environmental statement

KEWAUNEE NUCLEAR POWER PLANT

WISCONSIN PUBLIC SERVICE CORPORATION

DOCKET NO. 50-305

Fig. III-6: Observed Plume Dispersion for Point Beach Unit 1 on June 25, 1971.

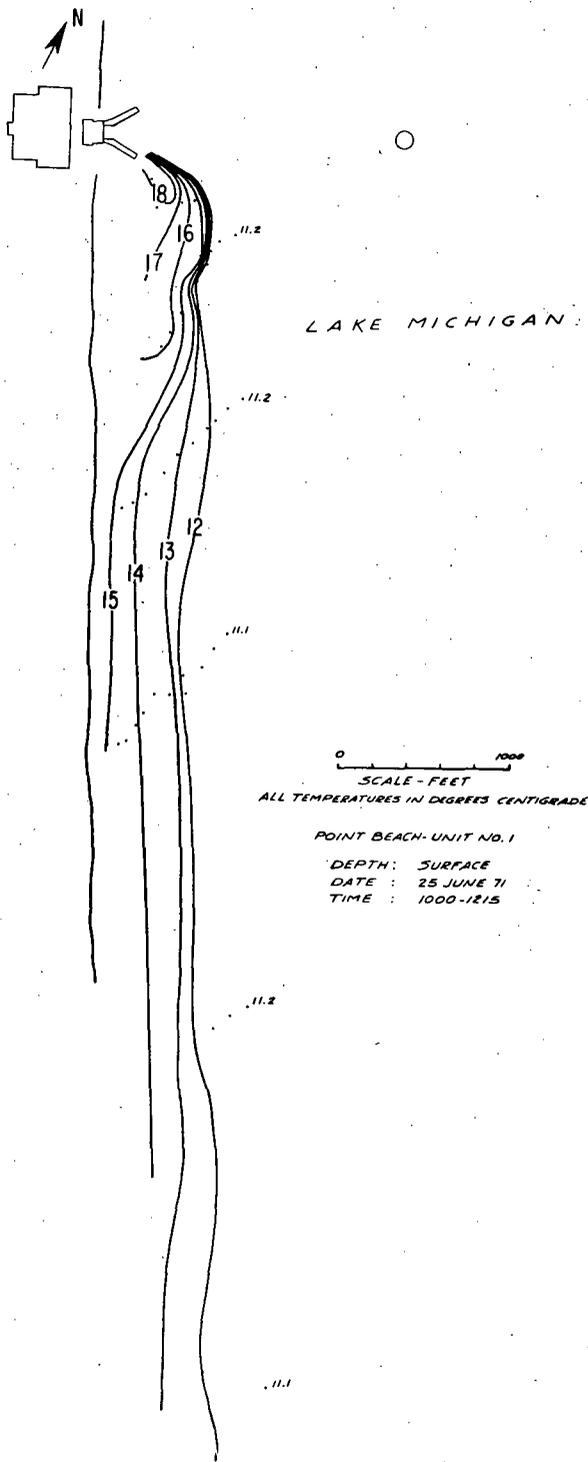
The effect of strong shore-parallel currents would be to cause the plume of warm water to flow near the shore, as shown in Figure III.6 (for the Point Beach Plant). However, the conditions that promote these strong near-shore currents, i.e., strong winds from the north, northeast, and southeast, also create rough lake conditions, a great deal of turbulence (as indicated by turbidity levels) and waves breaking in the vicinity of

the beach and outfall. These conditions promote mixing and partially, if not completely, compensate for the plume being bounded on one side by the shoreline. Figure III-6 illustrates that the initial temperature has been attenuated within a few hundred feet as a result of the ambient turbulence. Thus, strong shore-parallel currents are not expected to subject entrained organisms to maximum temperatures for a greater time than that estimated in Section III.D.1.b.

Fig. III-7: Observed Plume Dispersion for Point Beach Unit 1 on August 31, 1971.

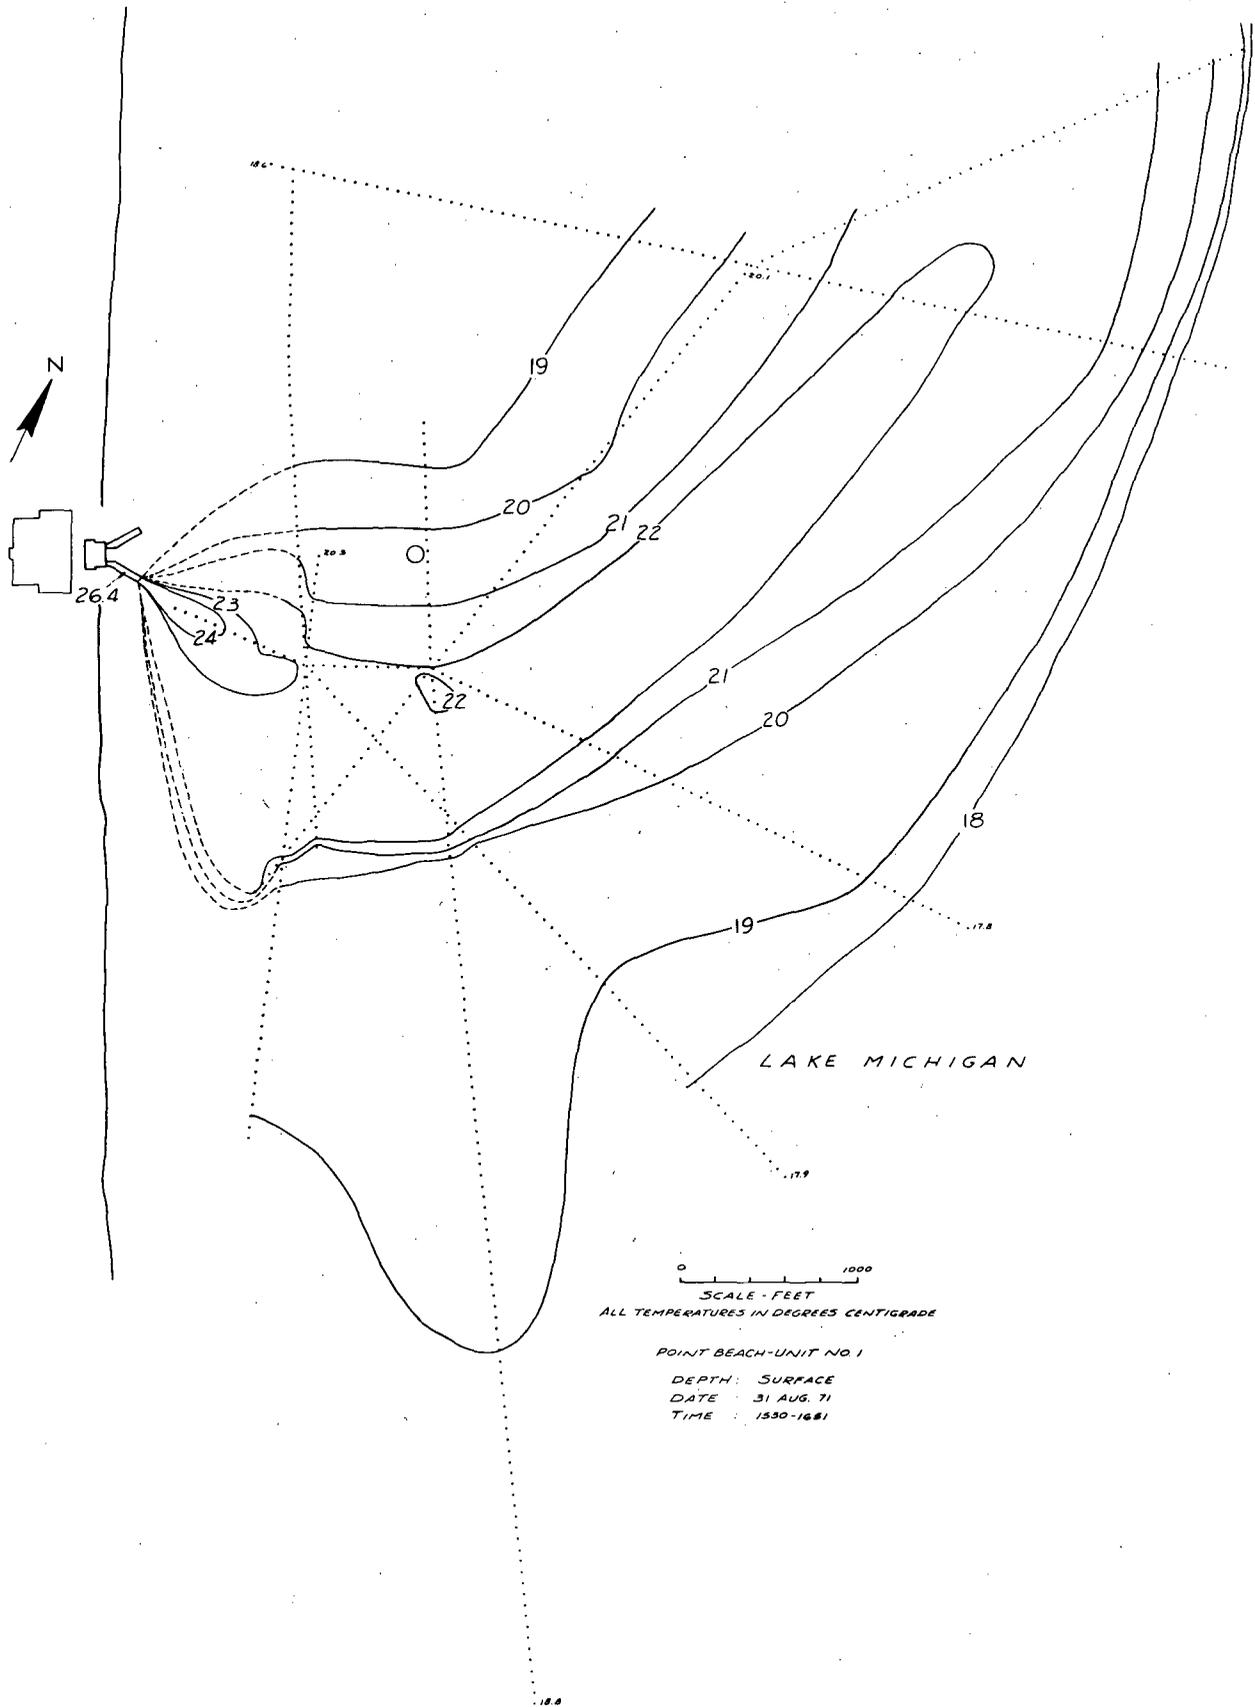
We agree with AEC in the conclusion in the second paragraph on page III-9 that the mathematical model may not present an accurate indication of plume size. However, Figure III-7, showing the Point Beach plume on August 31, 1971, would appear to indicate that the applicant's data are reasonable. The Point Beach Unit 1, August 31, 1971, plume indicated distances in excess of a mile. The area enclosed by the 3°F isotherm is a significant area even though it may be less than 1,000 acres, as estimated by the applicant, or more than 254 acres, as estimated by AEC.

It is not clear that the large Point Beach plume shown in Figure III-7 proves or disproves the Applicant's analysis, as stated in the comment. It is a large plume and was included with Figure III-6 to illustrate the variability of plumes observed in an area very near the Kewaunee site. An analysis of ambient lake current data at the Point Beach site indicated that the current shifted from a southerly to a northerly flowing current during the morning of August 31. Thus, for a period of time the plume was mixing, not with ambient lake water, but with water previously associated with the plume. The Applicant's model did not represent this situation. Figures III-8 and 9 represent the plume on the following morning and afternoon (Sept. 1) and show a considerable reduction in size.

Figure. III-15. WATER USAGE BY THE KNPP.

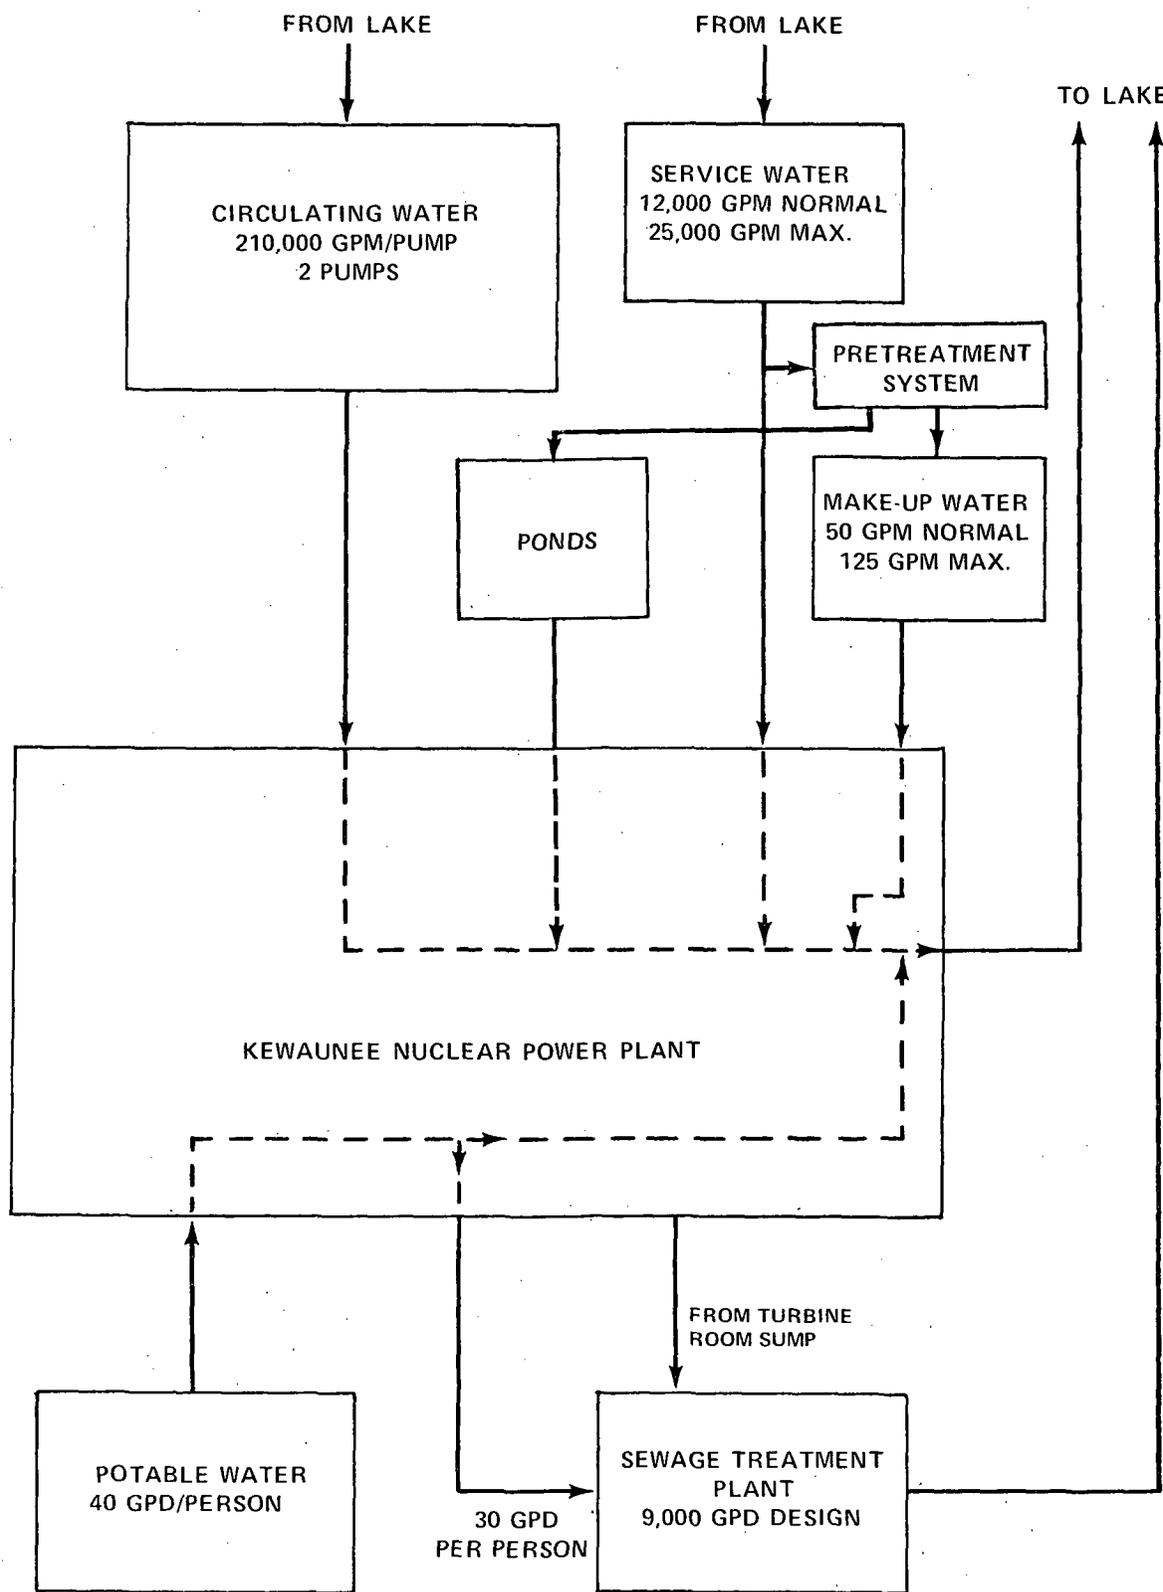
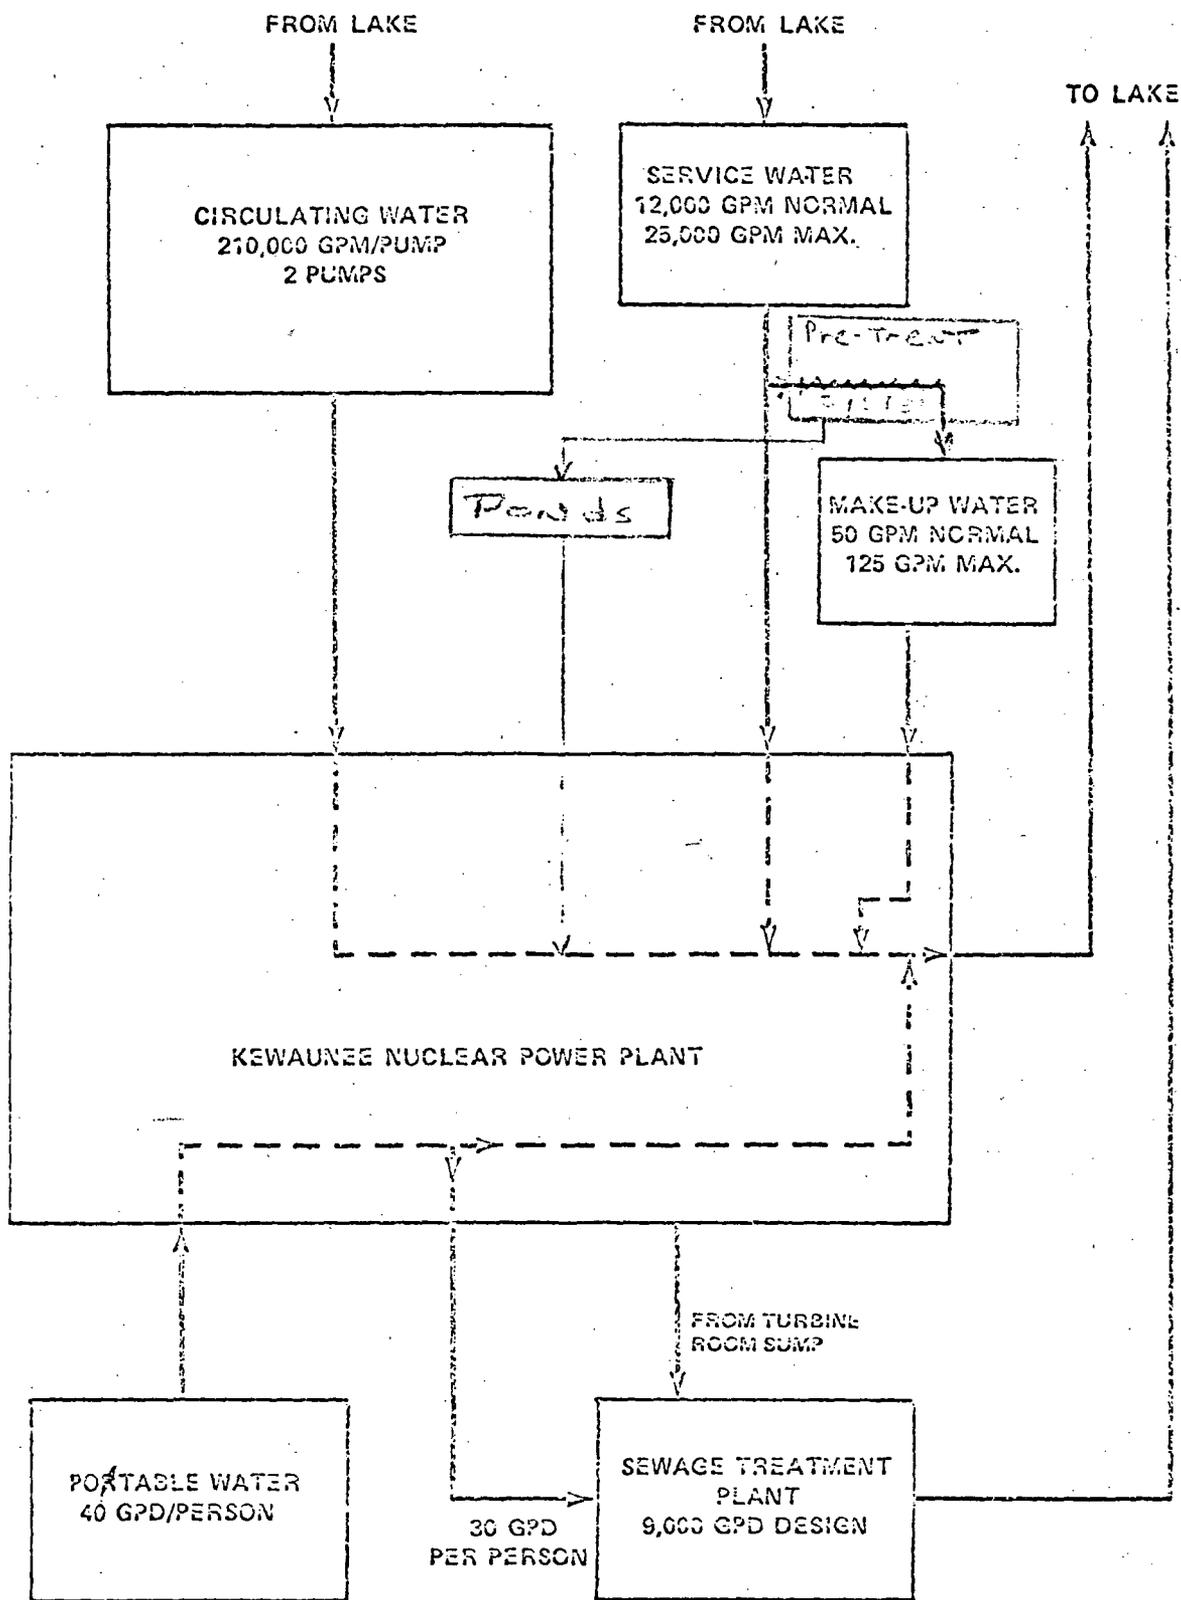
<u>Comment No.</u>	<u>Ref. Page, Figure, Table</u>	<u>Remarks</u>
1	Page II-24	Last paragraph - Analysis of surface wells mineral content have shown values of 840 ppm rather than 330 ppm.
2	Page III-23 Figure III-13	WPS has agreed to modify the steam generator blowdown treatment vent to vent to the condenser instead of venting to atmosphere.
3	Figure III-14	See attached Figure III-14 indicating flow paths.
4	Page III-26	Top of page - Last sentence change to: "Alternatively, the bottoms can be sent directly to waste solidification for processing."
5	Page III-30	Item 2, secondary coolant, boiler blowdown of coolant containing chemicals are discharged directly to the lake by way of the circulating water and are not routed to the neutralizing tank.
6	Page III-30	WPS has modified the make-up water system. (See attached - Service Water Pretreatment System.)
7	Figure III-15	See attached Figure III-15 indicating changes.
